STAFF RECOMMENDATION
2206 Eighteenth Avenue South
June 15, 2016

Application: New construction- addition; Partial demolition
District: Belmont-Hillsboro Neighborhood Conservation Zoning Overlay
Council District: 18
Map and Parcel Number: 10416003900
Applicant: Craig Kennedy, AIA
Project Lead: Melissa Sajid, Melissa.sajid@nashville.gov

<p>Description of Project: Application is to demolish a non-contributing addition and to construct a rear addition.</p> <p>Recommendation Summary: Recommendation: Staff recommends approval of the application with the following conditions:</p> <ol style="list-style-type: none">1. Instead of bricking in the window on the right façade, the window shall remain with the glass blacked over on the outside and the opening wallboarded over inside the house; and2. Staff approve the final window and door selections prior to purchase and installation. <p>With these conditions, staff finds that the proposed addition and detached structure meet Sections II.B.1. and II.B.2. of the <i>Belmont-Hillsboro Neighborhood Conservation Zoning Overlay: Handbook and Design Guidelines</i>.</p>	<p>Attachments A: Photographs B: Site Plan D: Elevations</p>
--	--

Figure 2: Rear addition to be demolished

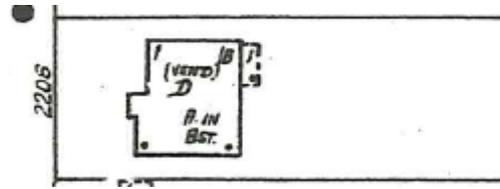
Partial demolition: Demolition is proposed for an existing partial-width rear addition (Figure 2). The 1957 Sanborn maps indicate that the rear addition was originally a covered porch that subsequently was enclosed. Since the portion to be demolished has been altered and does not contribute to the character of the historic house, Staff finds that

the demolition of the rear addition is appropriate as it is located at the rear of the house and it has been altered so that it no longer contributes to the character of the historic house.

ELEVATIONS

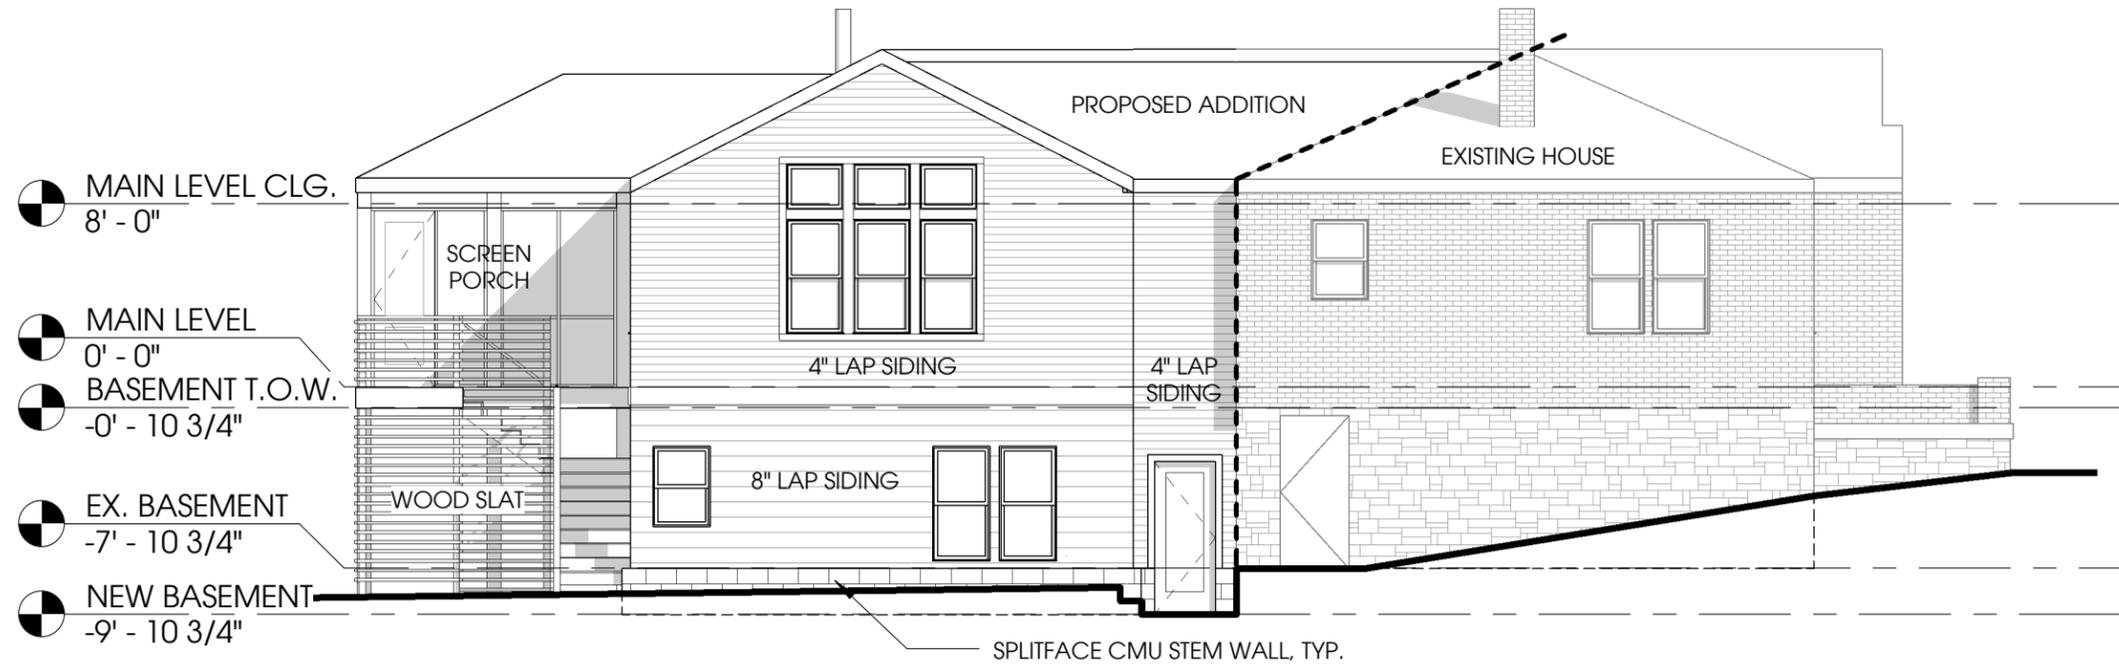
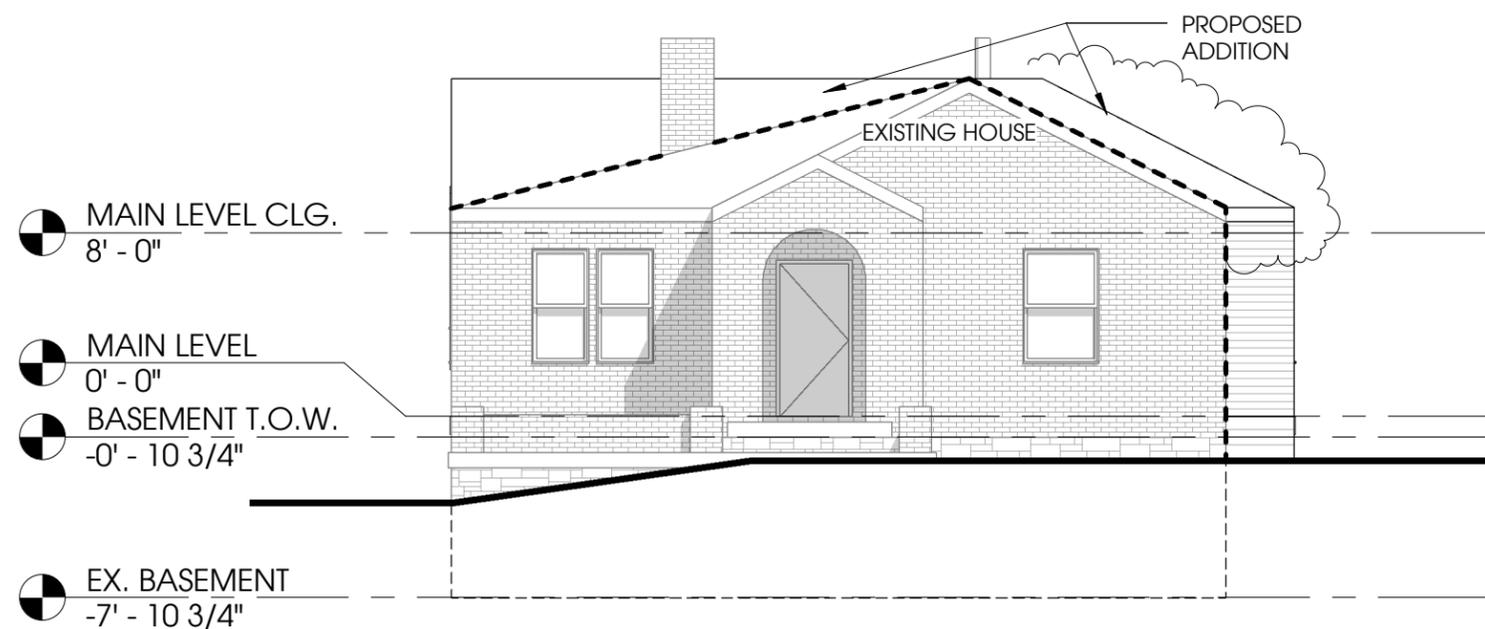
Height & Scale: The addition has a maximum ridge height that is equal to the ridge height of the historic house. While no additional height is proposed, part of the roof of the addition will be visible from the front given the roof form of the existing house. Staff finds this to be appropriate as the amount of the addition that will be visible is minimal and will be all roofing material, further obscuring its visual impact.

The design guidelines also state that an addition should not be both taller and wider than the existing house. In this case, the addition is wider on the right side and also appears taller from the front. The front facing gable on the existing house combined with the height and width make it difficult to hide the addition from the front. The proposed hipped roof of the addition minimizes the visual impact of the addition of the street.

Materials: The addition is clad with fiber cement siding with fiber cement trim. The plan shows a split-face CMU foundation, and the roof will be asphalt shingles to match the existing. The porch railings will be wood slats. Materials for the windows and doors are unknown. Staff recommends including a condition that staff approve the final window and door selections prior to purchase and installation.

1. Instead of bricking in the window on the right façade, the window shall remain with the glass blacked over on the outside and the opening wallboarded over inside the house; and
2. Staff approve the final window and door selections prior to purchase and installation.

ELEVATIONS

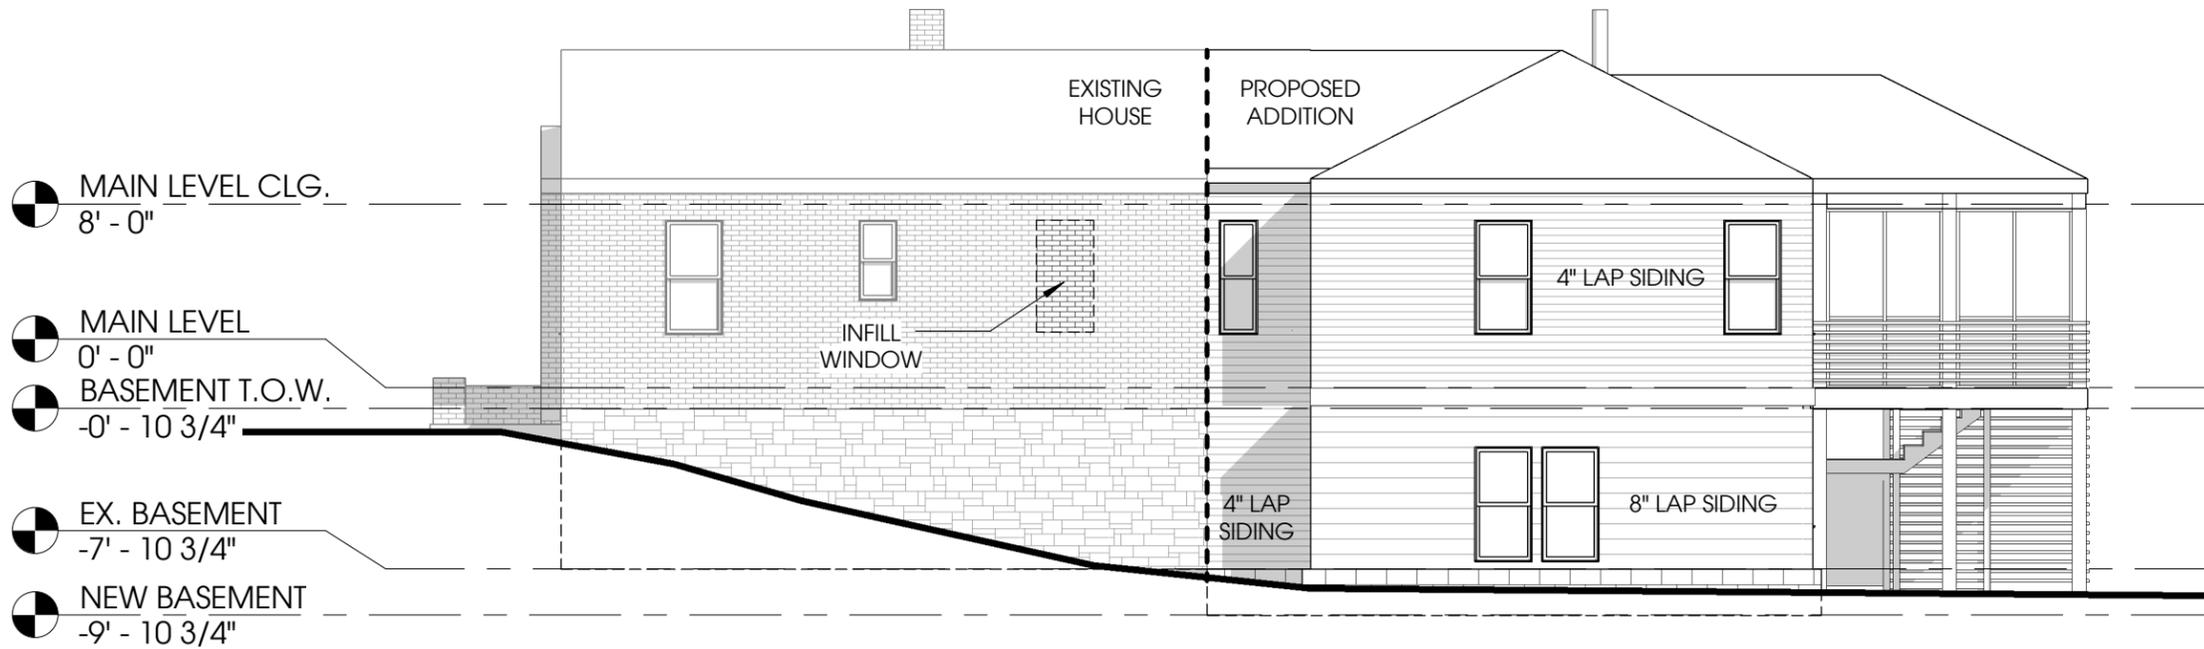
The addition is wider than the existing house by three feet (3') on the right side. The part of the proposed addition that is wider is one-story and is located approximately thirty-four feet (34') behind the front corner of the existing house. Staff finds that the width of the addition on the right side is appropriate in this case for several reasons. The width of the historic house is thirty-two feet (32'), and while this is greater than the thirty feet (30') threshold required by the guidelines, it is still narrow for this block where building widths range from thirty-two feet to forty-one feet (32' – 41'). The addition sits back from the front of the house significantly and the amount of protrusion is minimal. In addition, the lot slopes significantly from the front to the rear, and the guidelines state that exceptions may be made when there are constraints present such as steep slopes.

Proportion and Rhythm of Openings: The windows on the proposed addition meet the historic proportion of openings, being generally twice as tall as they are wide. There are no large expanses of wall space without a window or door opening. Staff finds the project's proportion and rhythm of openings is consistent with Section II.B.2.g
